12 December 2024

**SSD-61000021 – 146 Arthur Street, North Sydney – Built-to-Rent
Lendlease Investment Management Pty Ltd - Submission**

Figure 1 Aerial map of 141 Walker Street adjoining 146 Arthur Street, subject of SSD-6100021

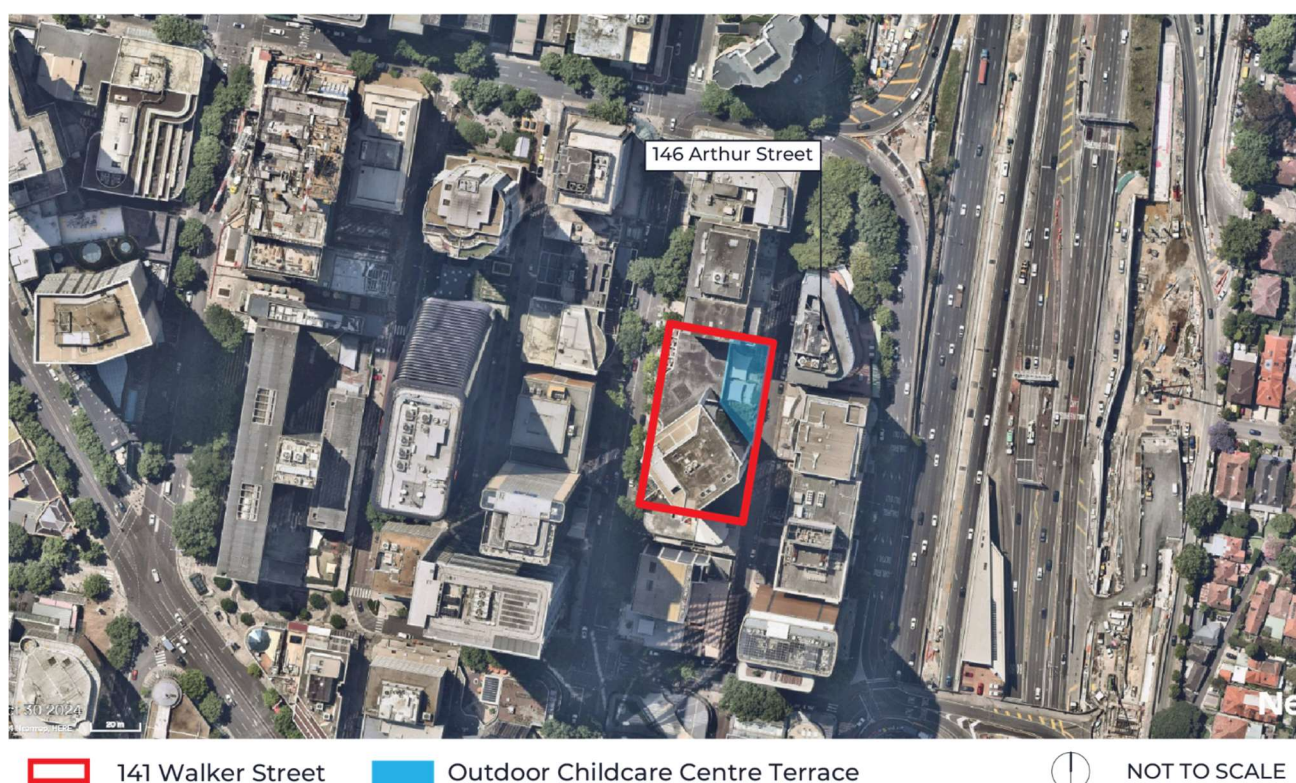
Most significantly, the childcare centre has a large terrace that looks to the east over Little Walker Street, located to the north of the main tower element on the site at 141 Walker Street. This is the only outdoor space servicing the childcare centre (see Figure 1).

- The proposal fails to take into account the additional overshadowing of the outdoor terrace utilised by the Guardian Childcare and Education Centre to the south-west of the proposed

development at 146 Arthur Street. This terrace is the primary outdoor space for the childcare centre, and given the density of the CBD location, overshadowing is already a critical issue.

Figure 3 Overshadowing, September 11am
(terrace in yellow)

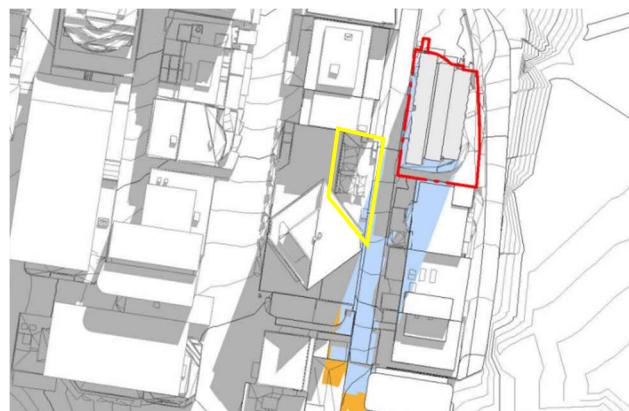
As per the overshadowing diagrams accompanying the EIS, there is additional overshadowing being caused by the new tower, including that resulting from the portion of the tower that is within the height limit, as well as that which is extending beyond the height limit.

There is very obviously a portion of the tower that is newly overshadowing the childcare terrace in both March and September, whilst it appears that the terrace is already in shade at the winter solstice in June as per the diagrams. Again, given the CBD and dense nature of the locale, protecting solar access to this facility throughout the year is critical and should be more closely considered in the application. Figure 2 and Figure 3 below demonstrates the additional overshadowing to the childcare centre terrace shown in the documentation provided by Aqualand.

Further to the above, it is unclear as to whether the additional height proposed beyond the height limit will have an impact on this terrace area and the access to light that is provided from solar reflecting on adjoining buildings. Whilst the additional height may not directly impact solar access to the terrace itself, additional overshadowing on the tower element of 141 Walker Street caused by the additional uplift may result in a darker terrace for the childcare, through the loss of reflective light.

Overshadowing to the childcare centre has the potential to have long lasting impacts for the facility and its operations. Based on this, it is requested that the overshadowing impacts of the development in relation to the terrace are reviewed and, if necessary, changes to the scheme are made so that the sensitive use of the childcare and the adjoining terrace is better protected from overshadowing impacts. This will enable the critical operation of the childcare to continue to the highest standard.
